Chapter 5

Revisions to the Draft EIR

This chapter includes revisions to the Draft EIR by errata as allowed by CEQA. The revisions are presented in the order they appear in the Draft EIR, with the relevant page number(s) indicated with italicized print. New or revised text is shown with underline for additions and ~~strike-out~~ for deletions.

Figure 2-11
Proposed Open Space Network
 City Place Santa Clara

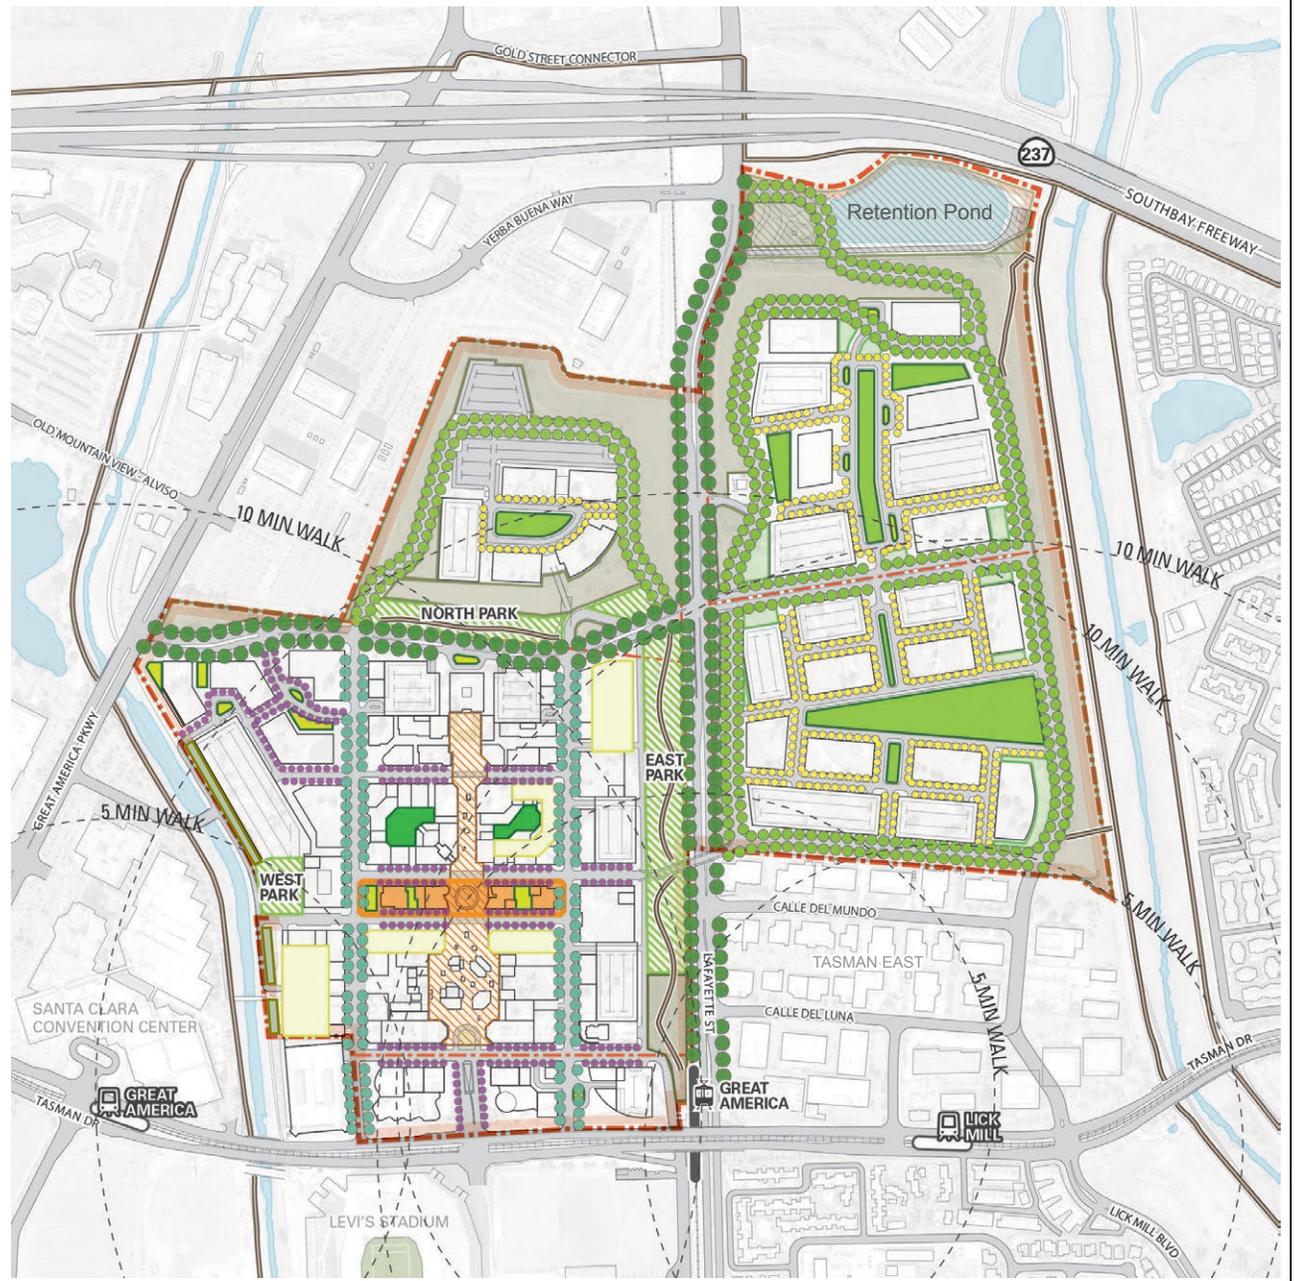
The following description of landscaping and open space has been added before the first full paragraph on page 2-20 of the Draft EIR. In addition, a corresponding figure has been added to the Draft EIR as Figure 2-11.

As depicted in Figure 2-11, the Project would include the following parks and open space program elements within the City Center:

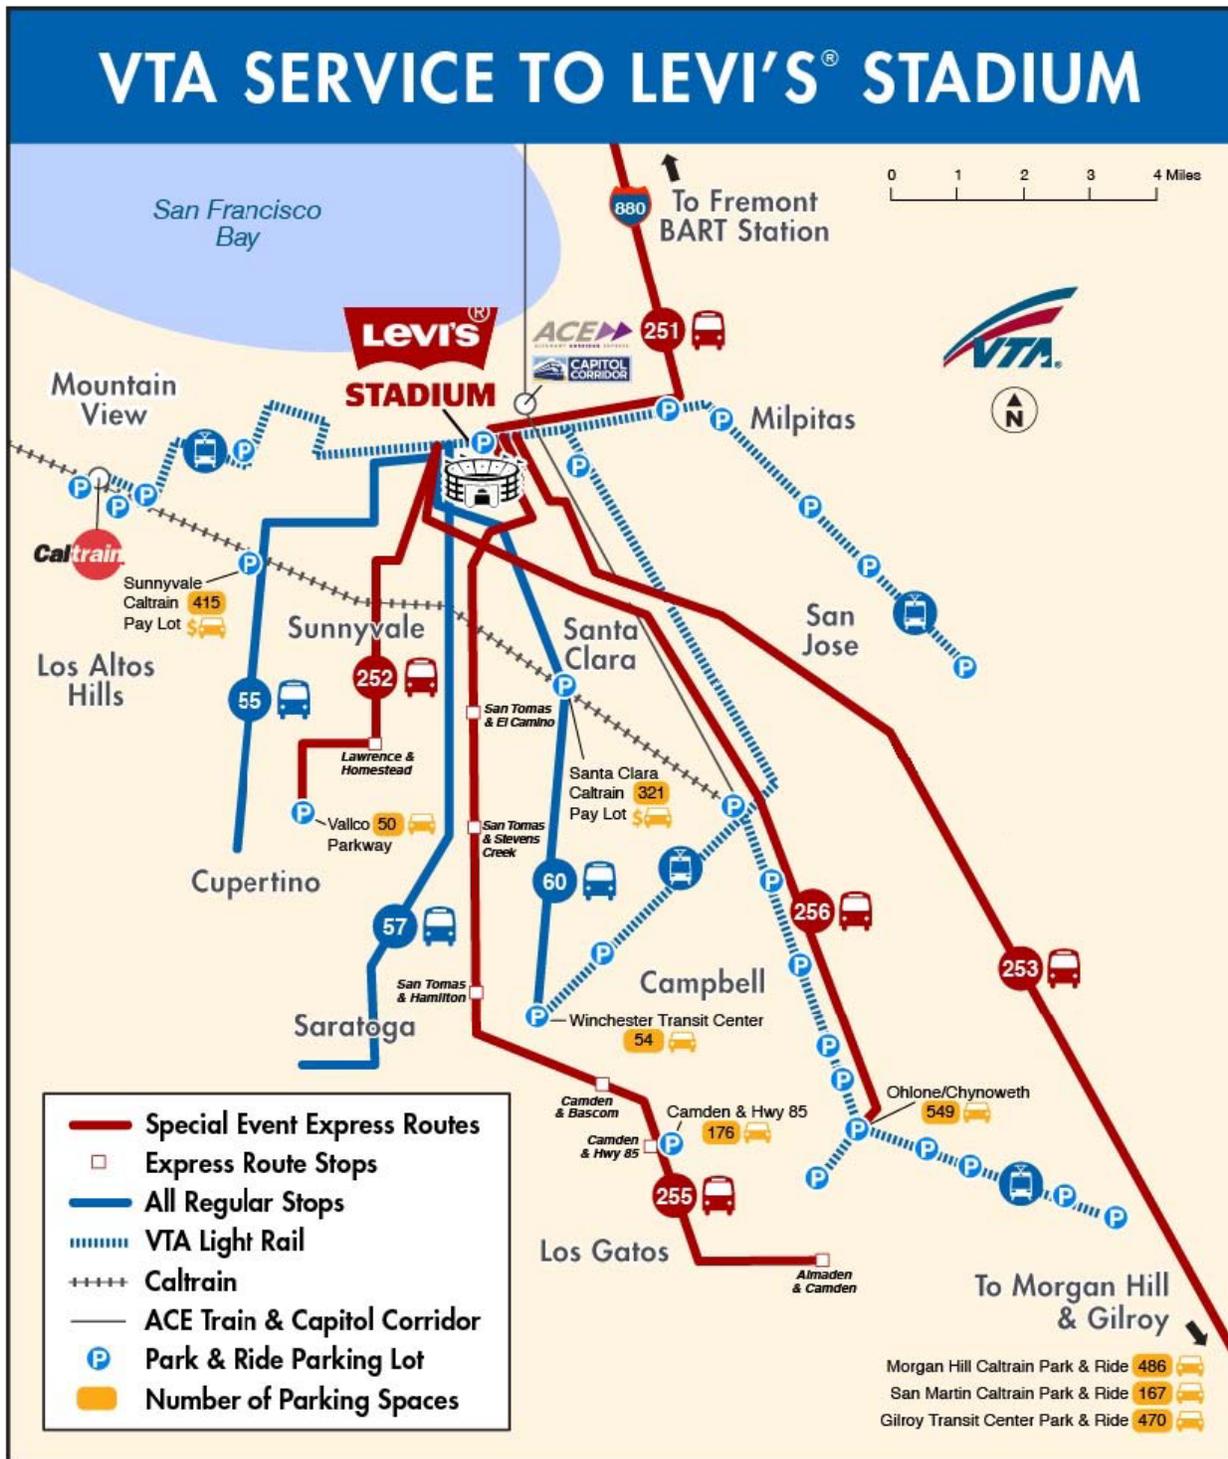
The VTA Service to Levi's Stadium figure on page 3.3-222 of the Draft EIR has been updated so as not to show bus line 254. This update is shown on the following page.

Figure 3.8-2b
Potentially Jurisdictional Waters of the U.S. and State
City Place Santa Clara

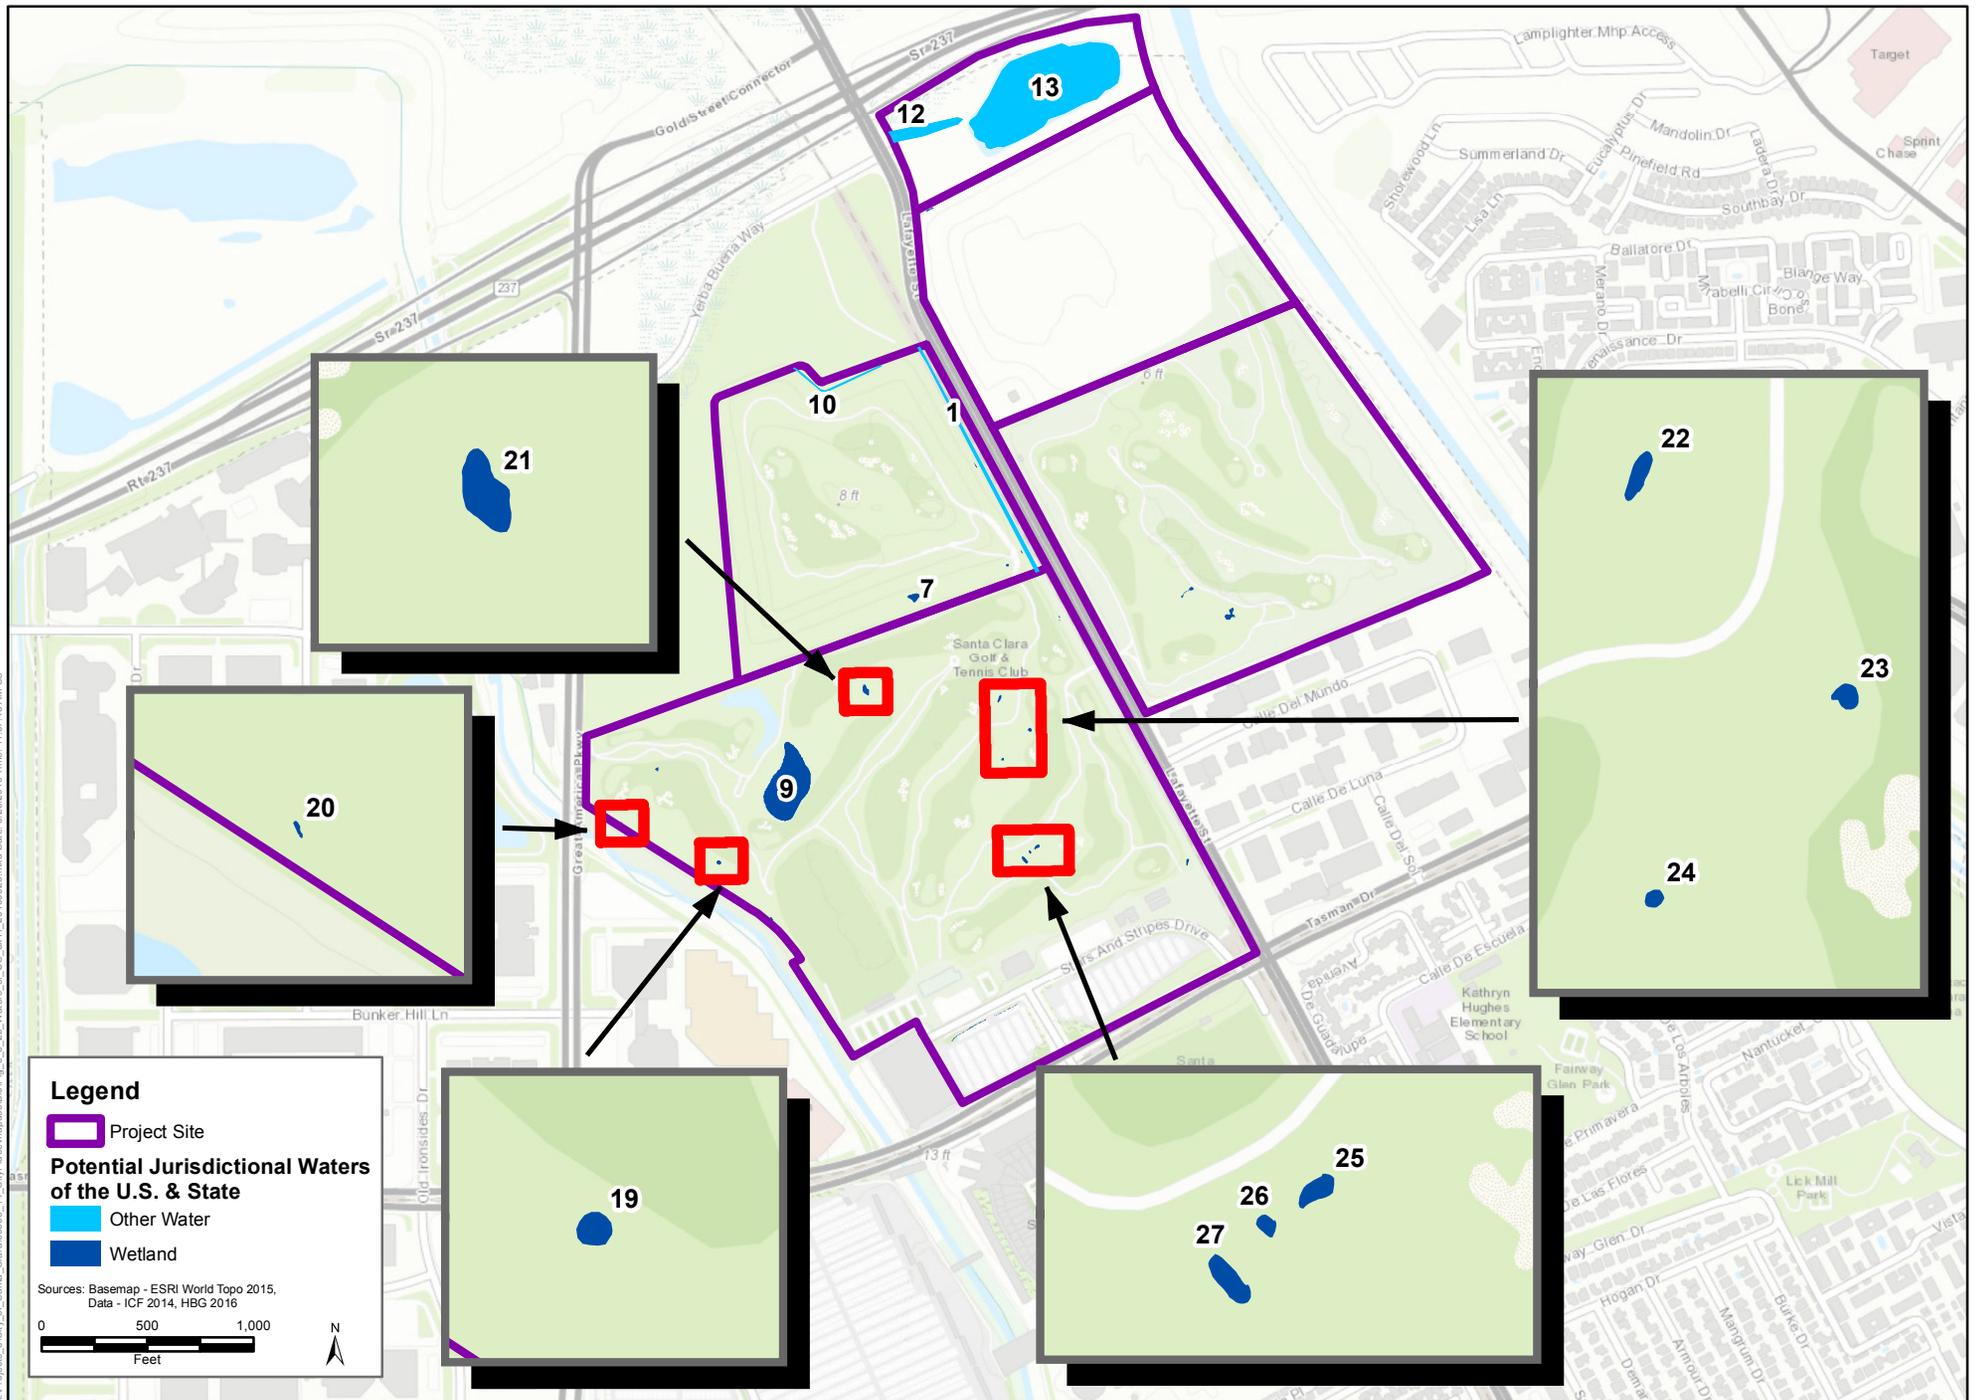
The Draft EIR text on page 3.8-8 has been revised as noted below. A new figure and corresponding table detailing the locations for potential waters of the U.S. on the Project site have been added to the Draft EIR. The new figure has been added as Figure 3.8-2 and the new table has been added as Table 3.8-1. The subsequent figures and tables in the section have been renumbered accordingly, although these changes are not shown.

Figure 3.10-2
Hydrological Features within the Project Vicinity

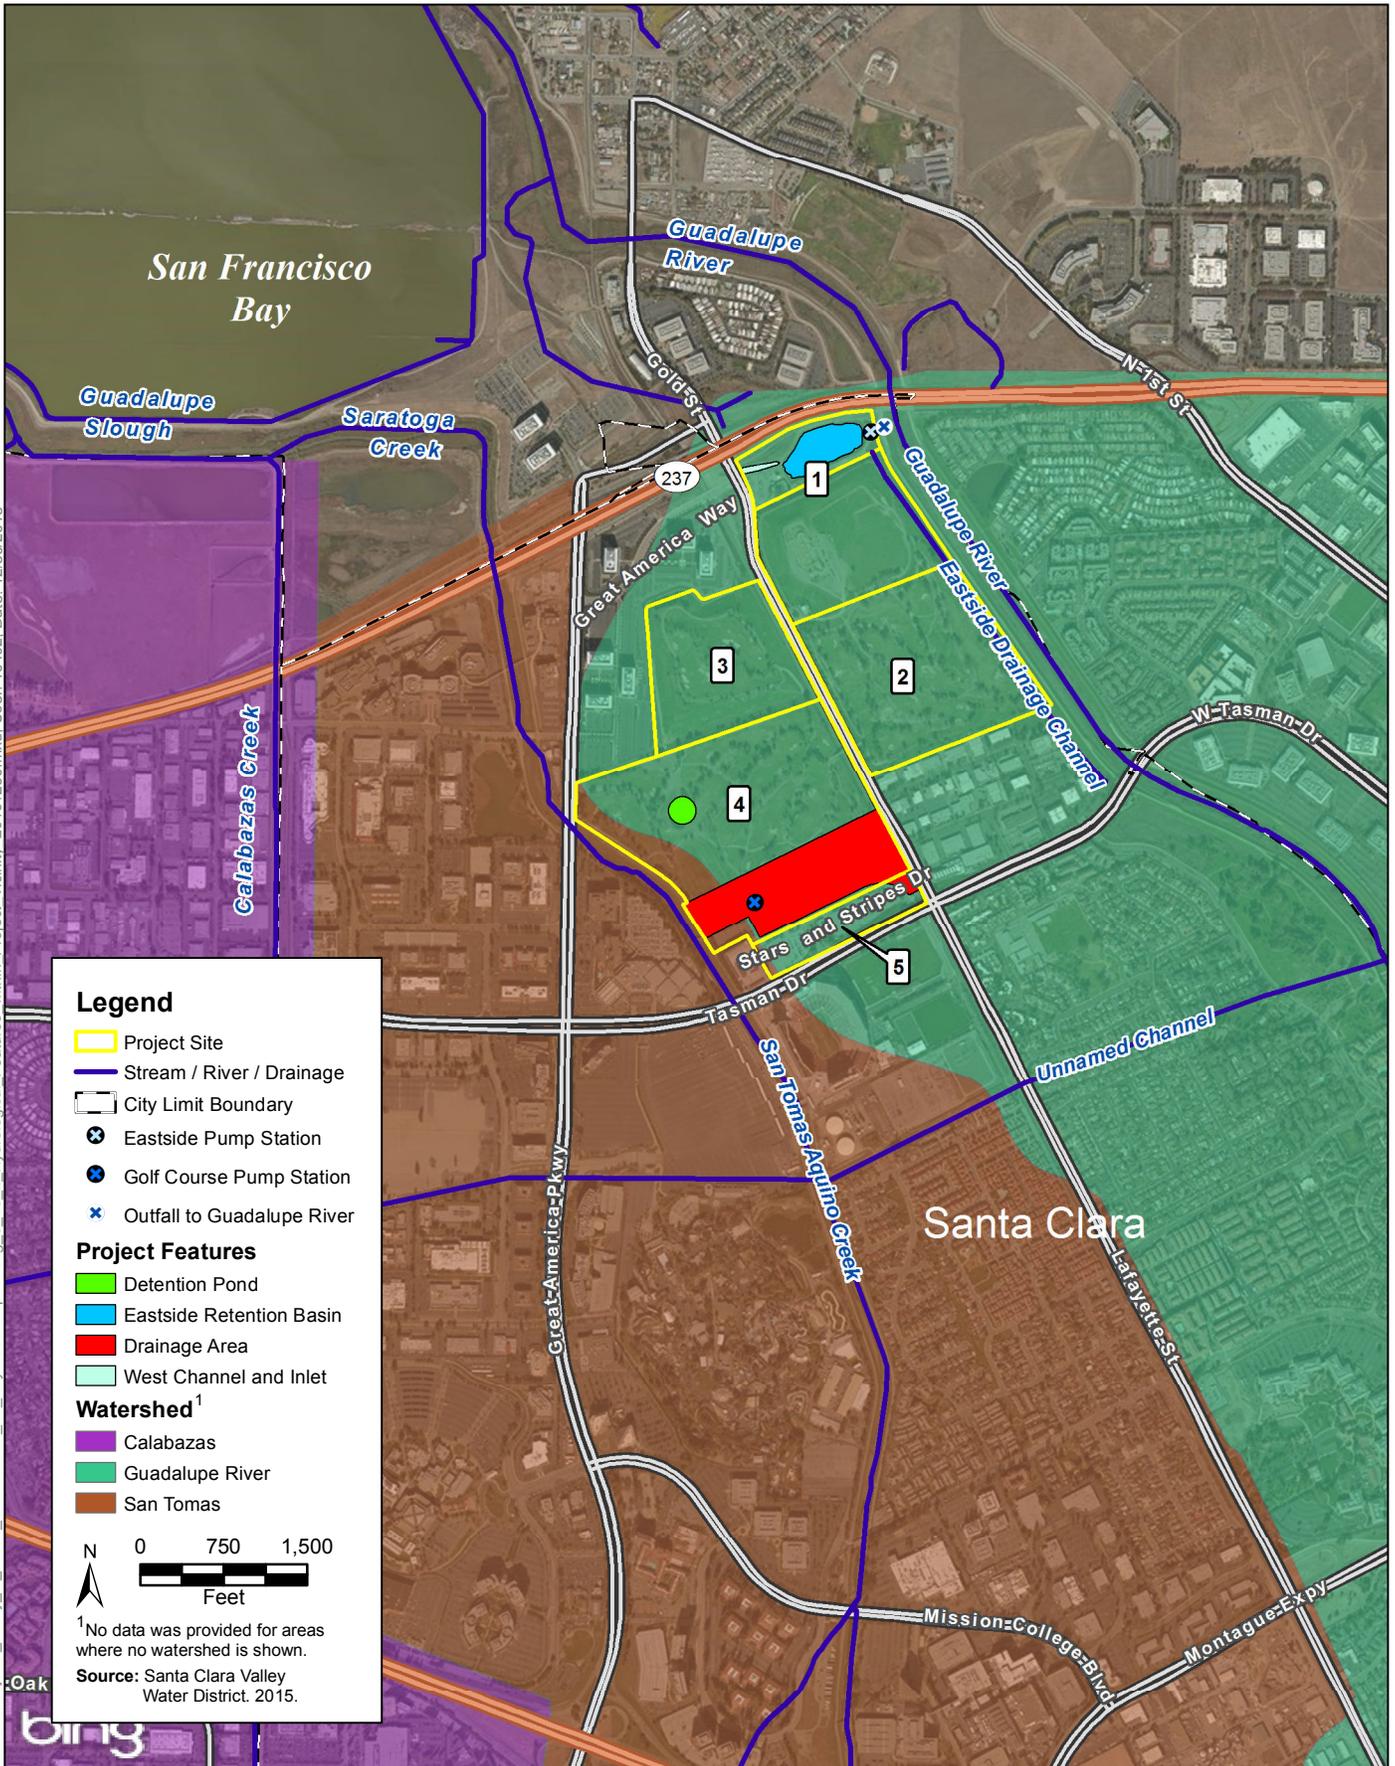
The following text has been added to the first paragraph under the subheader “Watershed Hydrology” on page 3.10-9 of the Draft EIR. In addition, Figure 3.10-2 has been updated to include watershed boundaries.

Figure 3.10-2 illustrates the hydrological features in the Project area. According to SCVWD watershed boundaries,⁷ the majority of the Project area is located within the Guadalupe River watershed, but a small area within the western portion of Parcel 4 is located within the San Tomas Aquino Creek watershed. Both the San Tomas Aquino Creek and Guadalupe River watersheds ultimately drain to the Lower San Francisco Bay watershed.
